SUBJECT: Forwards proposed changes to Chapter 17 of updated FSAR.

Re: Docket No. 50-275, OL-DPR-80
Docket No. 50-323, OL-DPR-82
Diablo Canyon Units 1 and 2
Proposed Revision to the FSAR Update, Chapter 17

REVISED PAGES TO DIABLO CANYON POWER PLANT FSAR UPDATE
CHAPTER 17

FSAR UPDATE
 UNITS 1 AND 2
 DIABLO CANYON SITE
 FIGURE 17.1-2
 ORGANIZATION CHART
 RELATED TO QUALITY ASSURANCE
 OF NUCLEAR POWER PLANTS

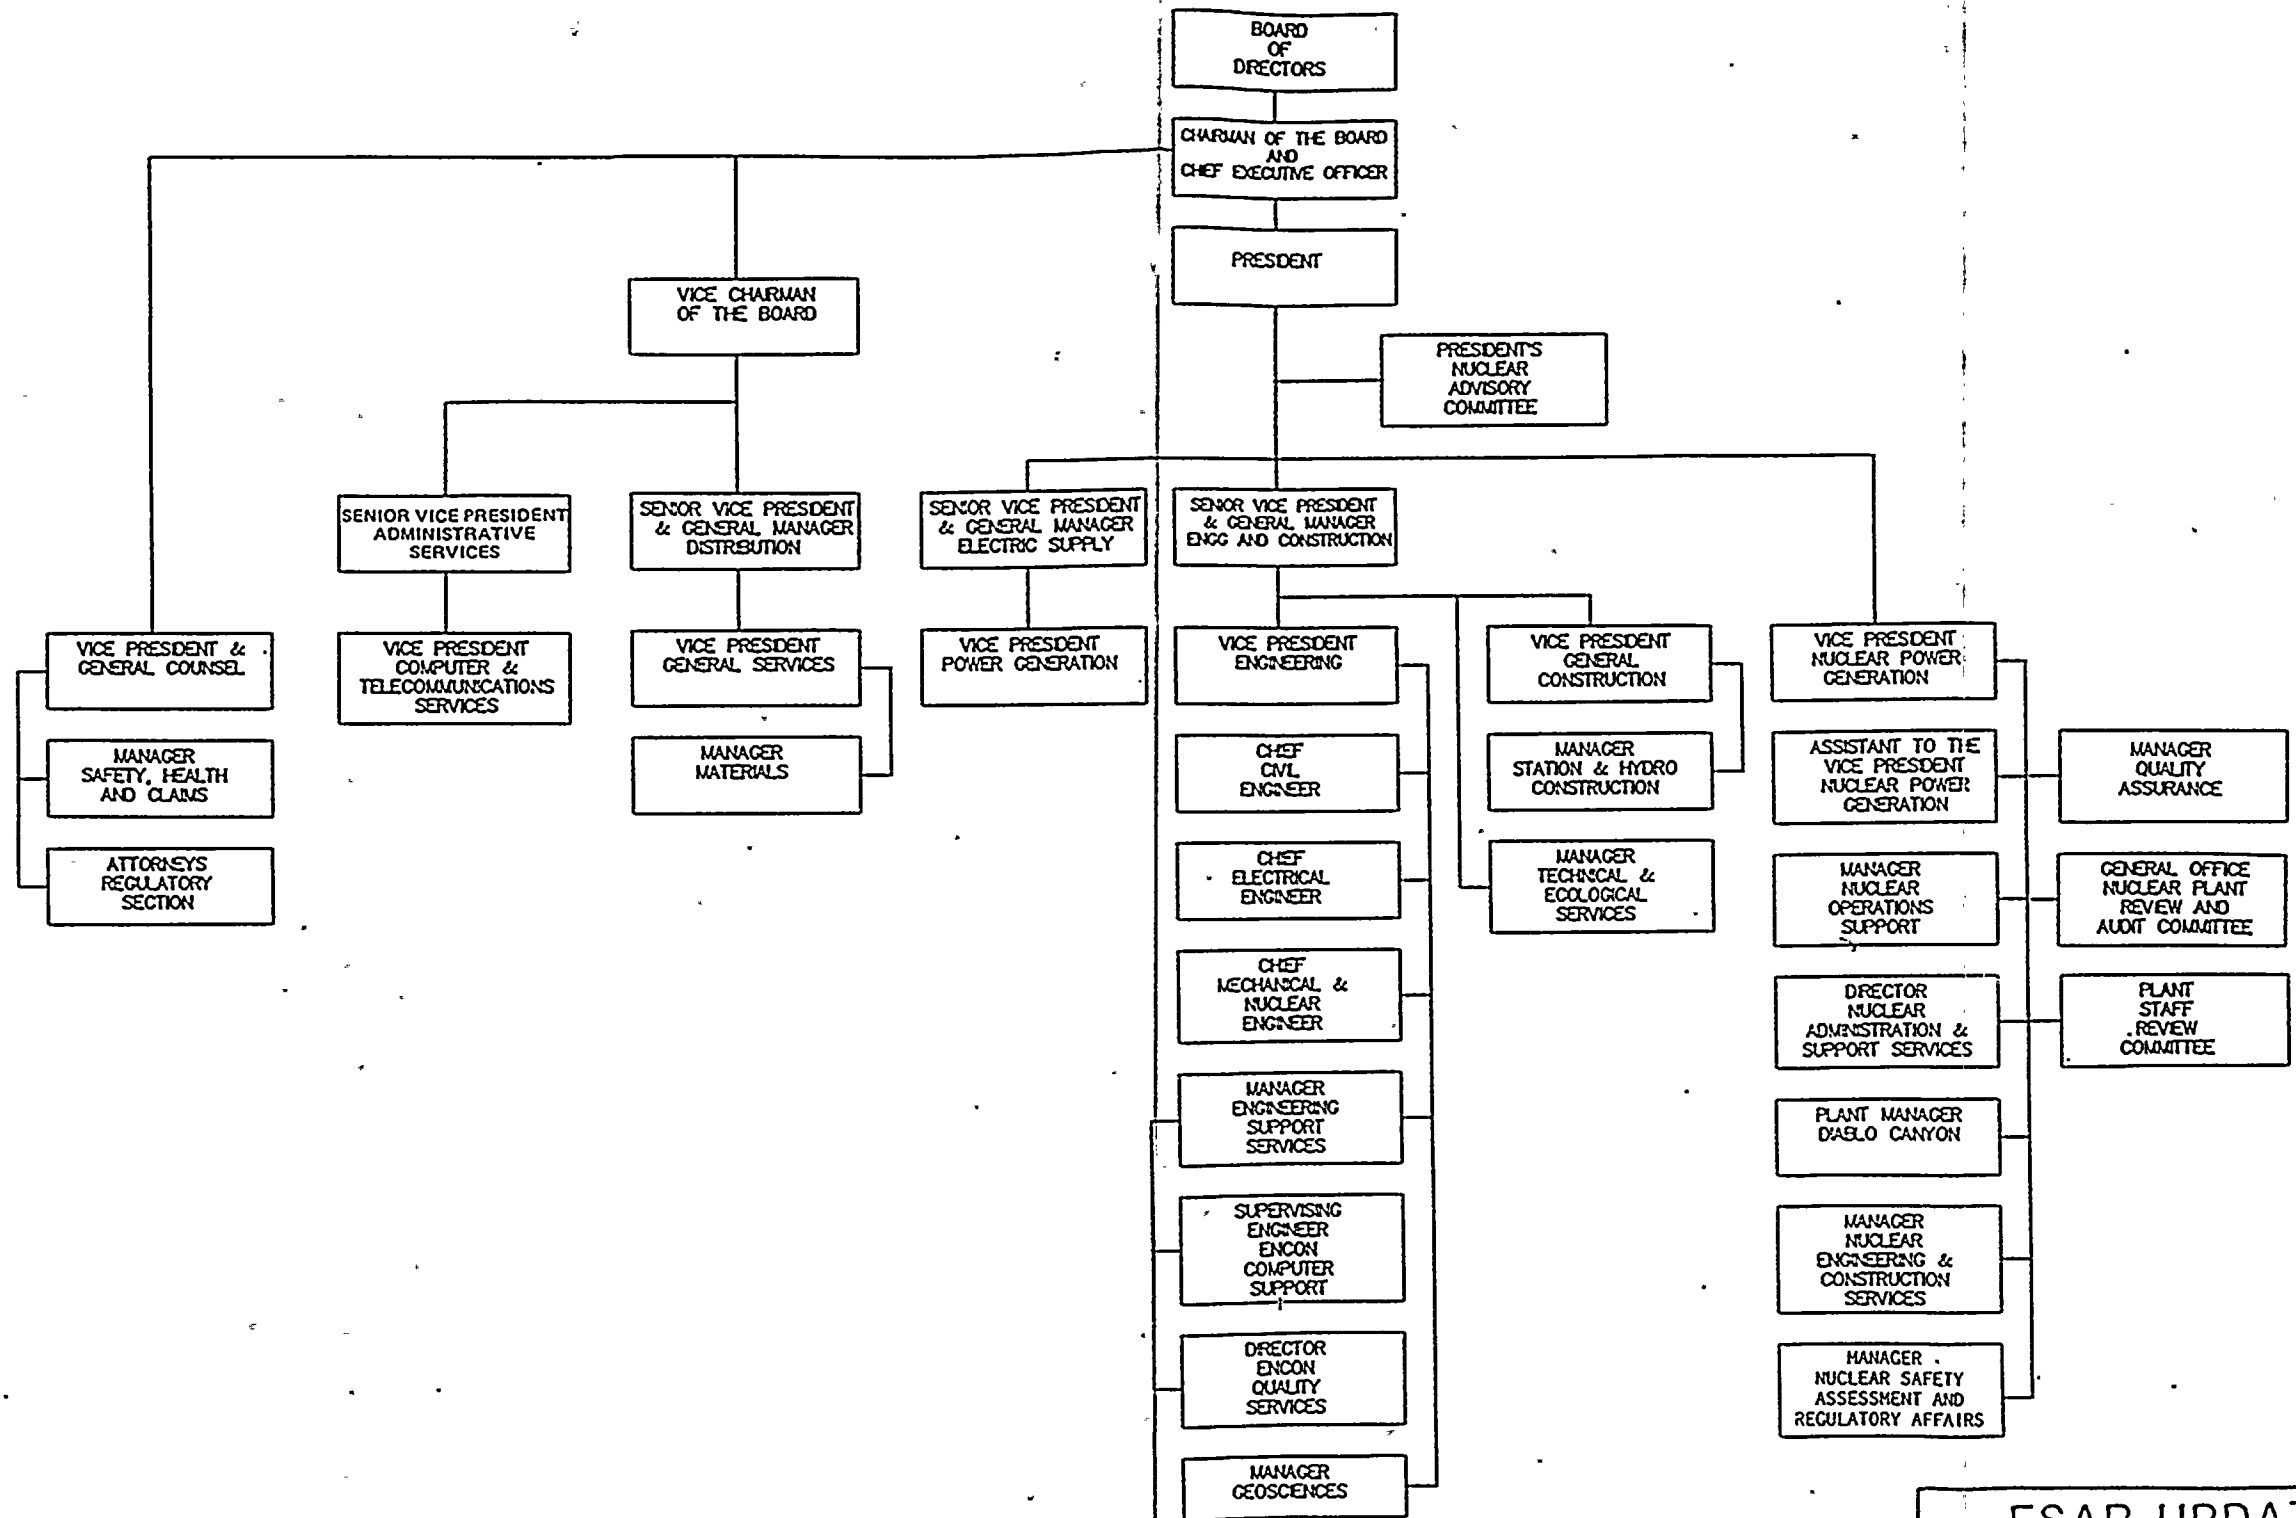
Additionally, the existing Figure 17.1-2, "Organization Chart Related to Quality Assurance of Nuclear Power Plants," shows the Manager, QA, reporting directly to the President of PG&E. PG&E proposes to have the Manager, QA, report directly to the Vice President, Nuclear Power Generation, as shown on the enclosed revision of Figure 17.1-2. The appropriate paragraphs of Chapter 17, Section 17.1, "Organization," have also been revised to reflect this proposed organizational change as indicated in the enclosure.

These changes within the PG&E organization are consistent with industry practice, where QA functions are within the purview of the corporate executive who has the overall responsibility for nuclear operations and safety. Additionally, such a reporting structure will allow for more direct management involvement by the Vice President in assuring the adequacy and effectiveness of the QA Program, while maintaining sufficient organizational freedom of the QA Department to ensure its independence.
